Pilgrim Station Organization

BOSTON EDISON COMPANY
PILGRIM NUCLEAR POWER STATION
DOCKET NO. 50-293

Attachment to LER 82-003/99X-2

Figure 6.2.2

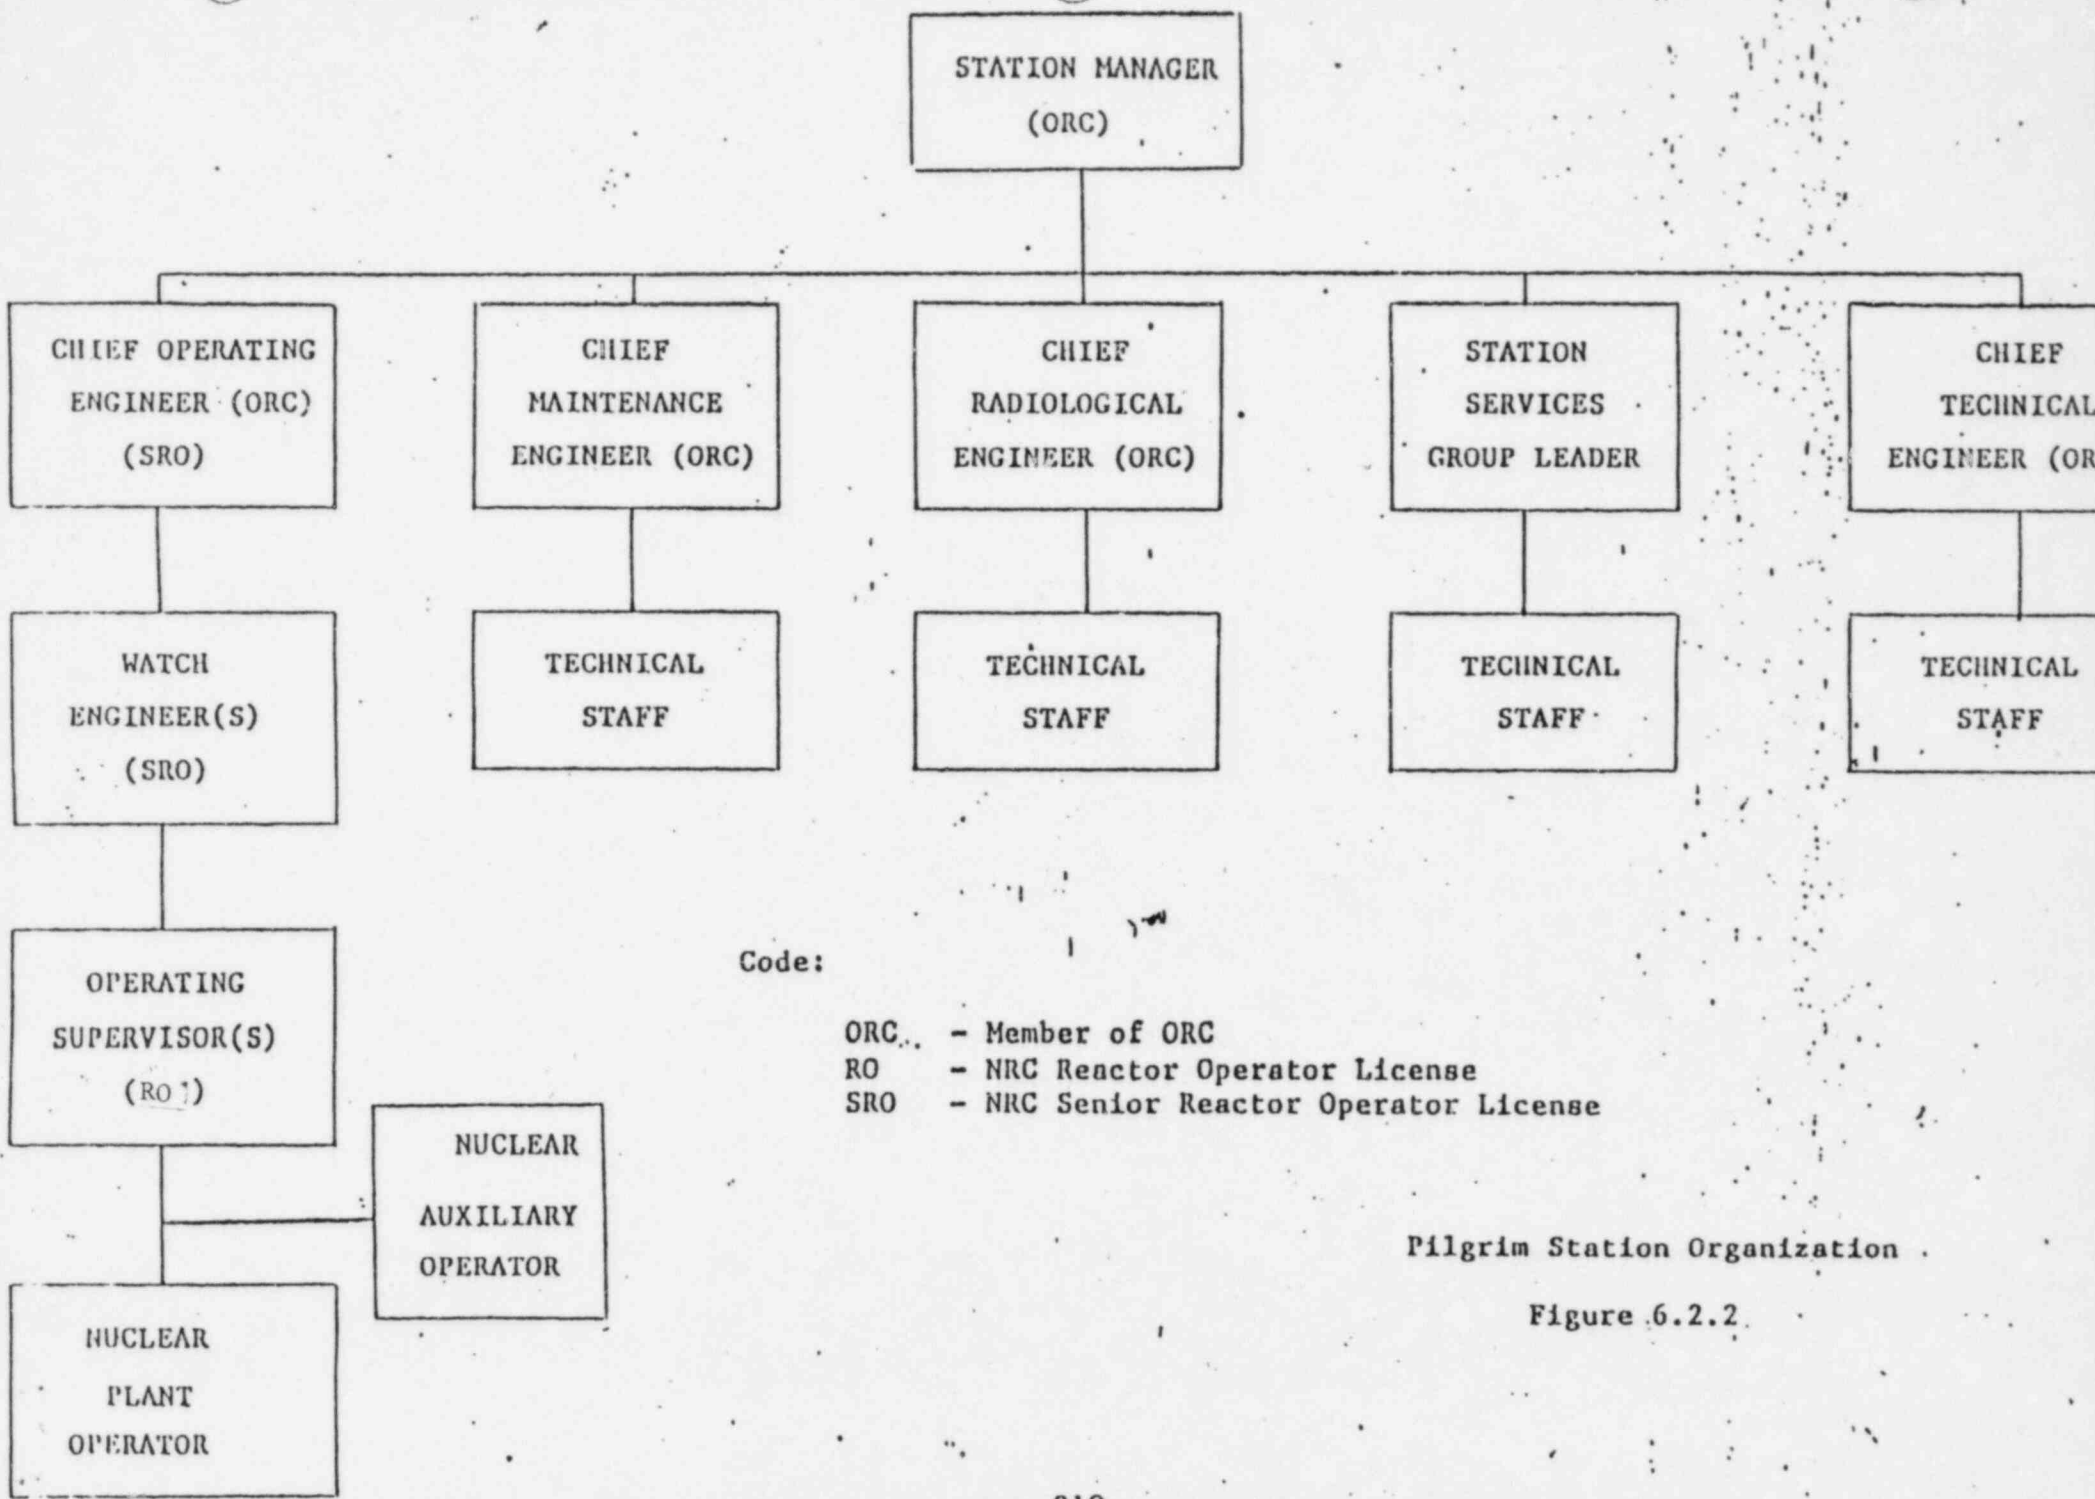
The following paragraphs are intended to clarify the functional and administrative responsibilities of the fire protection organization.

During a fire emergency the Fire Brigade Leader reports directly to the Station Manager or Emergency Director. The Fire Brigade Leader assumes overall direction of the Fire Fighting effort and directs personnel at the scene of the fire. Fire Brigade Leaders are qualified in accordance with the training requirements stipulated in the PNPS Training Manual. The Fire Prevention and Protection Officer can assume the position of Brigade Leader if he deems necessary. The position of Brigade Leader may be designated to any qualified individual.

The Fire Prevention and Protection Officer reports on a functional basis to the Station Manager and on an administrative basis to the Nuclear Operations Support Manager. On a functional basis the Fire Prevention and Protection Officer is responsible to insure that routine operation, maintenance and surveillance testing of fire protection systems and fire brigade response is being implemented properly. On an administrative basis the FPPO is responsible for evaluating fire protection adequacy, assisting in fire protection training, and reviewing and implementing fire protection administrative controls.
